## ROSE SENIOR LIVING AT PROVIDENCE JSP13-81

Public hearing at the request of Edward Rose and Sons for recommendation to City Council for approval of a Planned Suburban Low-Rise (PSLR) Overlay Development Agreement Application and Concept Plan. The subject property is 23.61 acres in Section 17 of the City of Novi and located on the north side of Eleven Mile Road and west of Beck Road. The applicant is proposing a 182 unit senior living facility.

# PLAN REVIEW CENTER REPORT

**Figure 1.** Site Aerial Photo (City of Novi Map Gallery, assessed March 10, 2014. Approximate project boundary shown in red). Regulated woodland areas are shown in green and regulated wetland areas are shown in blue.

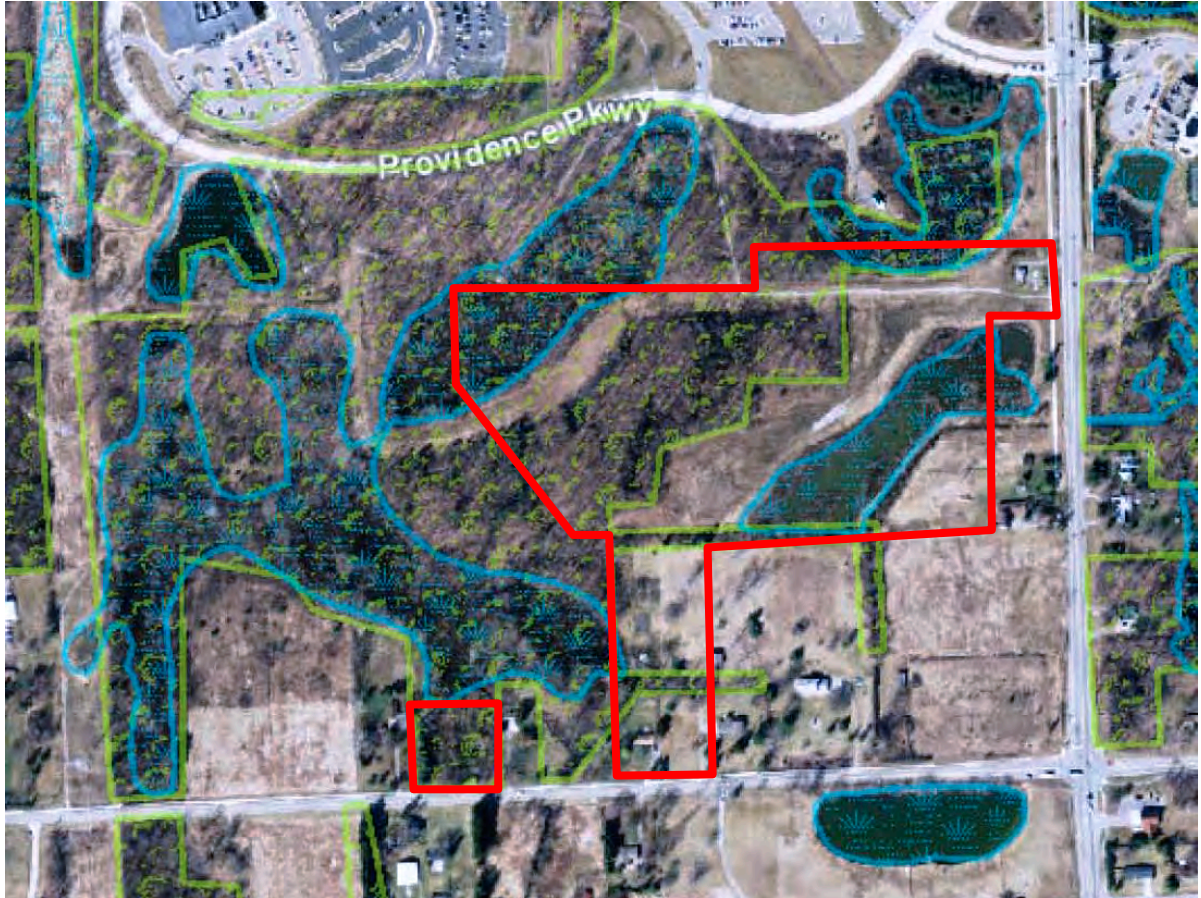
The entire site is shown to be 23.61 acres with regulated woodland mapped across a significant portion of the property. See Figure 1 (aerial photo).

**BICYCLE AND PEDESTRIAN MASTER PLAN**  
MFC-JOB NO: 20130948 SCALE: AS SHOWN  
DATE: MARCH 2014 SHEET: L203  
© 2013 Hubbell, Roth & Clark, Inc. All Rights Reserved

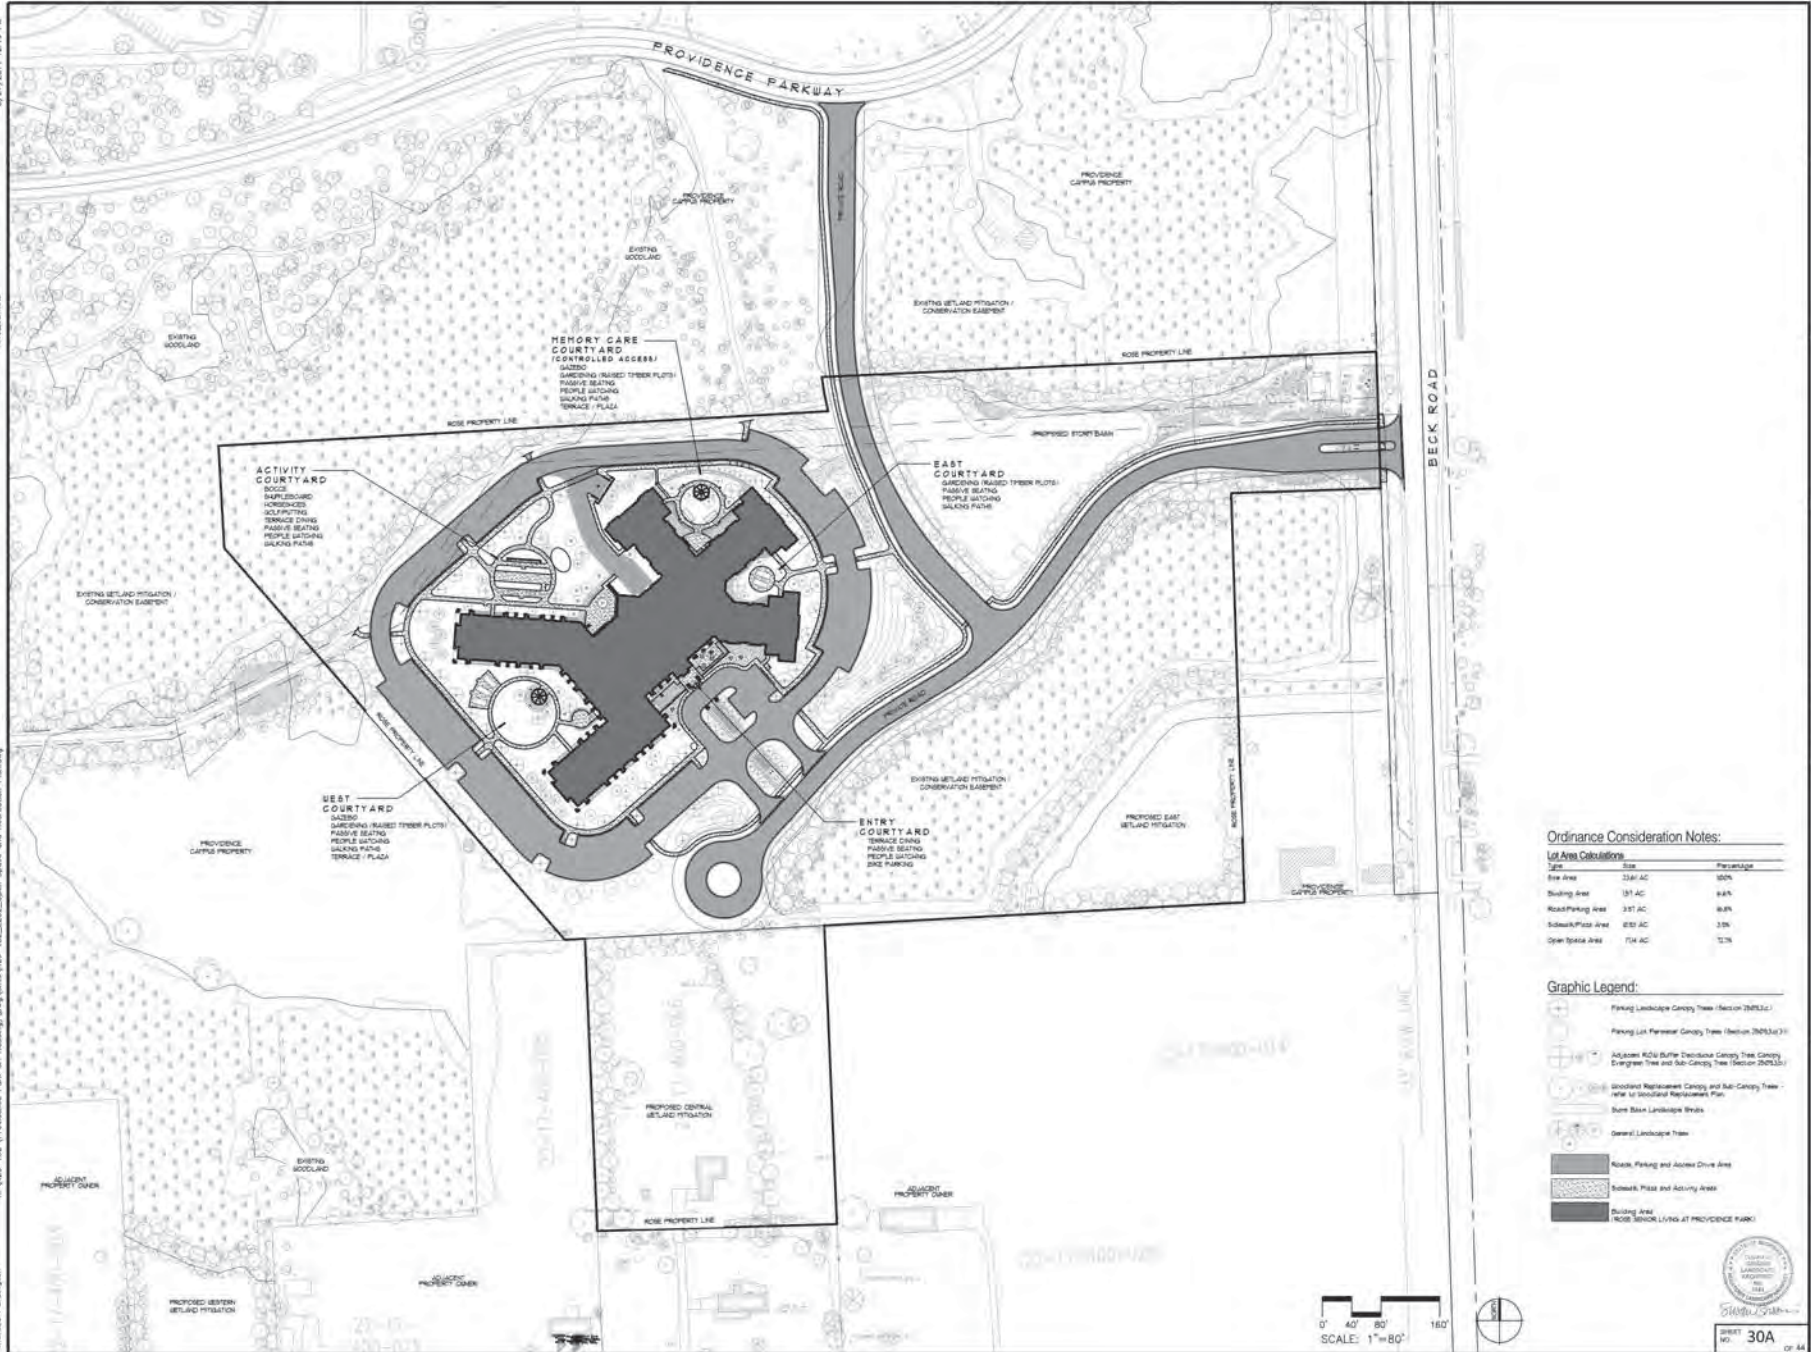
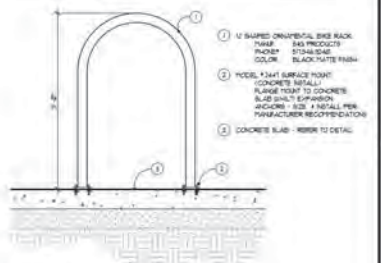
6. **Bicycle Parking Facilities:** The applicant has provided the required bicycle parking. However, details for the bicycle parking areas have not been shown. **The applicant should provide a**

**bicycle parking detail demonstrating compliance with the layout standards detailed in Section 2526.**

**Response: The layout and details for the bicycle parking have been provided on the Bicycle and Pedestrian Master Plan, sheet L203. This sheet has been provided on the compact disc for reference.**

<p><b>Response: A bicycle parking layout and detail have been provided on the Bicycle and Pedestrian Master Plan, Sheet L203. This sheet has been provided on the compact disc for your reference.</b></p>

FIGURE 1A: PROPOSE 471 FEET OF BUILDING LENGTH THAT EXCEEDS THE 180 FEET MAXIMUM BUILDING LENGTH.

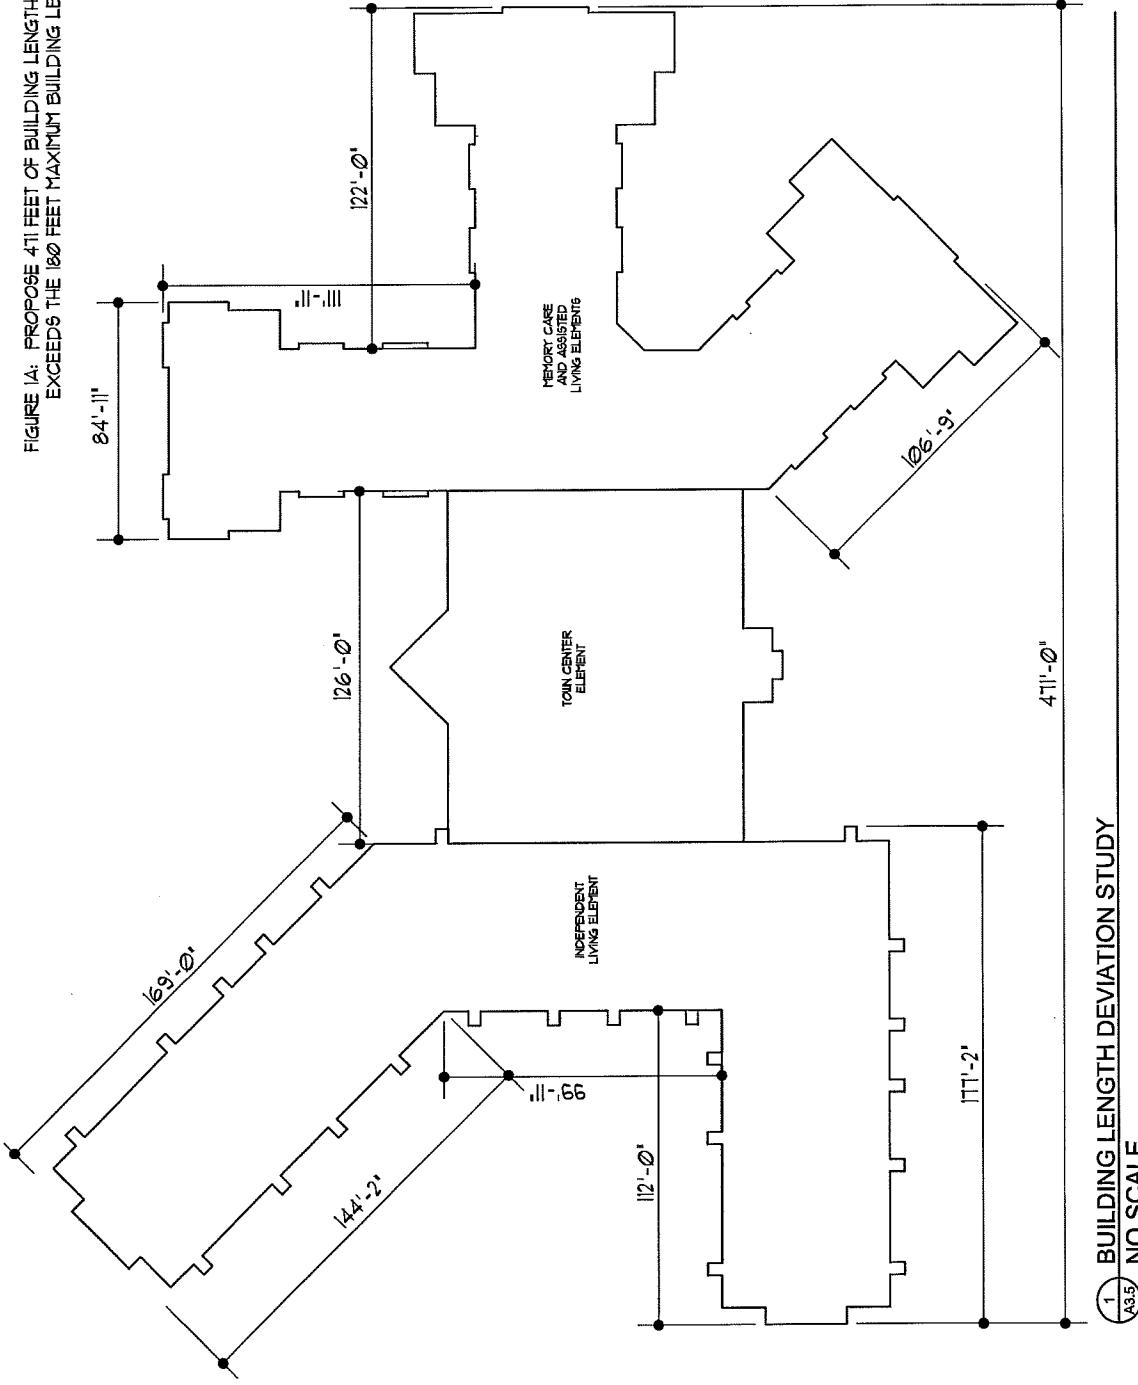
Narrative: The proposed building length is a function of the need to organize all levels of care around a town center. The connected community is made up of four elements, independent living/congregate care, assisted living, and memory care closely connected to the town center to allow the senior residents close and easy access to the building’s amenities. This connection is essential to the success of creating a sense of home, community, and operational efficiency, but can only be done through the design of a building with a longer overall length. We have gone to great measures to “break up” the facades of the building to appear as 4 separate residential elements as opposed to one long straight facade. There is no straight portion of the facade longer than 178 feet.

Graphic Depiction: Figure 1 attached and detail 1 on sheet A3.5 show dimensions of the varying building façade lengths. The proposed building setbacks are shown on Figure 1B attached and on plan sheet C 02.

FIGURE 2: PROPOSE A BUILDING HEIGHT OF 40'-9 1/2" THAT EXCEEDS THE 35 FEET MAXIMUM BUILDING HEIGHT.

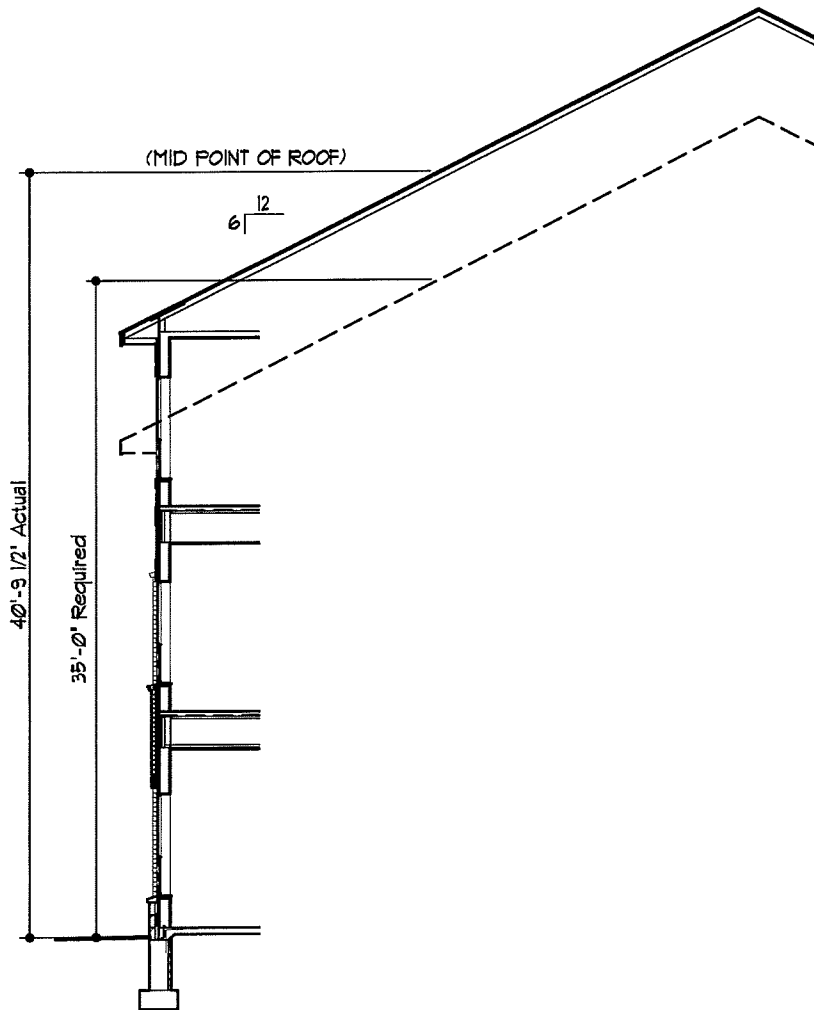
Narrative: The number of units is critical to the operational success of a community that includes the scale of building common areas, landscaped outdoor recreational amenities, natural features, and site improvements that the proposed development provides. Due to the configuration of the existing natural features (woodlands, wetlands, wetland mitigation and associated conservation easements) surrounding the proposed building, a practical difficulty exists to provide the number of units and associated improvements while minimizing impacts to natural features by minimizing the building footprint. If designed as a 2-story building, the proposed building would have a much larger footprint and would disturb 2.5 additional acres of the natural features. The height of the building is also largely a function of the need to get the resident living areas as close as possible to the town center areas and to limit the travel distances, which are critical to the less ambulatory senior's mobility and accessibility.

Graphic Depiction: Figure 2 attached and detail 5 on sheet A3.5 show a graphical depiction of the building height with dimensions.

FIGURE 3: PROPOSE GROUND FLOOR PEDESTRIAN ENTRANCE SPACING GREATER THAN 60 FEET APART ON A PORTION OF THE BUILDING

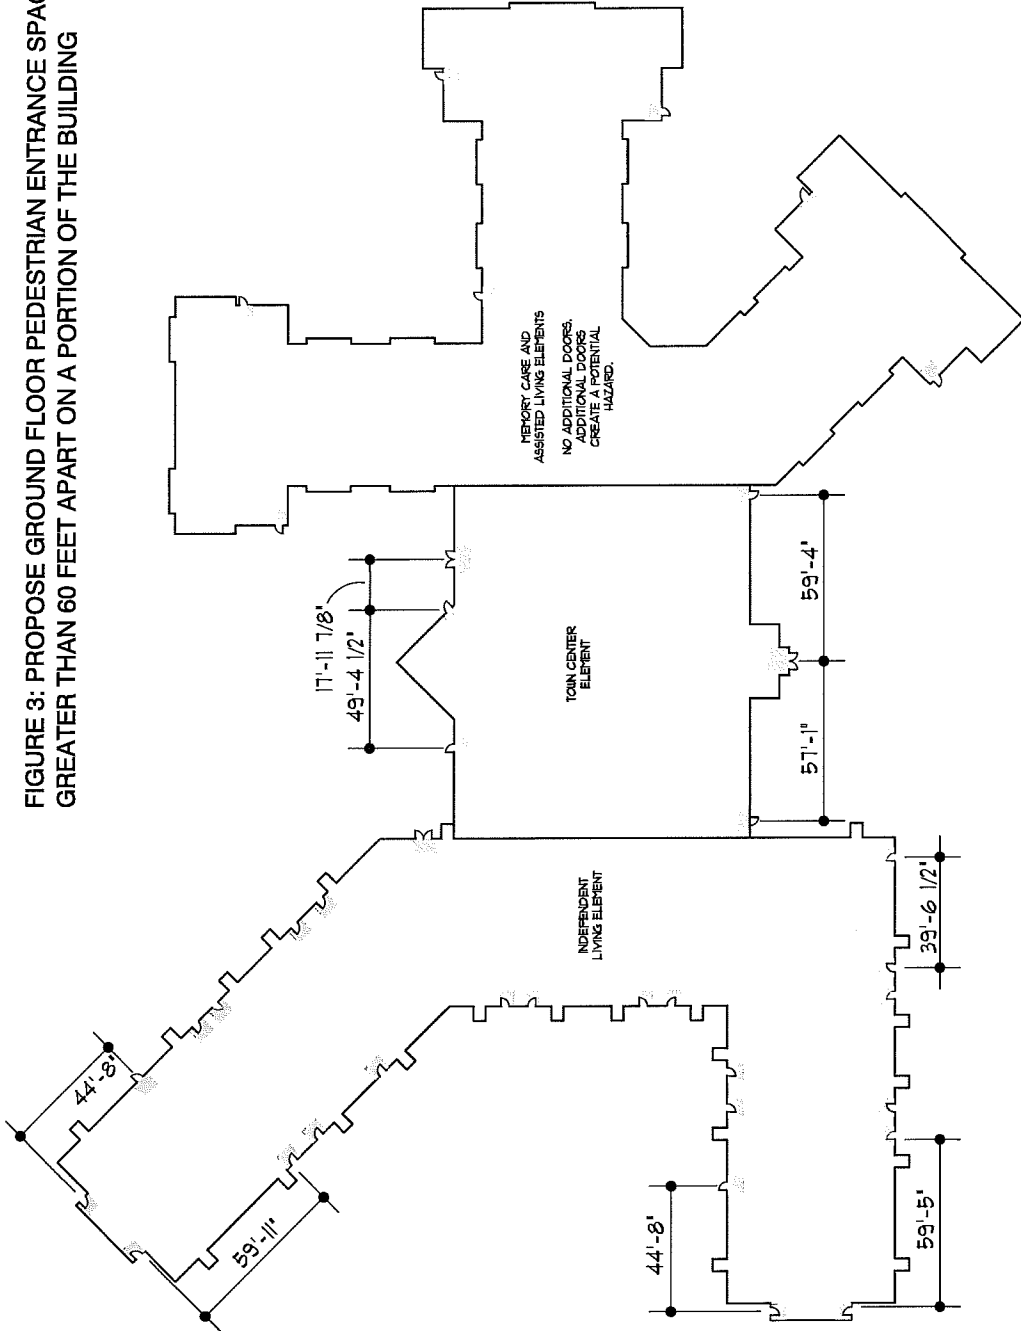
Narrative: The proposed building does have exterior patio doors spaced less than 60 feet apart for the more Independent seniors so a portion of the building meets the intent of the ordinance in that regard. The remainder of the building on first floor is a “neighborhood” specifically for the seniors who need the safety and support of a secured environment (assisted living and memory care); therefore, there are a limited number of controlled access doors spaced greater than 60 feet apart in this portion of the building. Also, it is imperative that the memory care neighborhood occur on the first floor to give the residents the ability to safely enjoy the outdoors in a secured and supervised garden designed specifically for individuals with Alzheimer’s and tendencies to wander.

Graphic Depiction: Figure 3 attached and detail 6 on sheet A3.5 show a graphical depiction of the ground floor pedestrian entrance spacing.
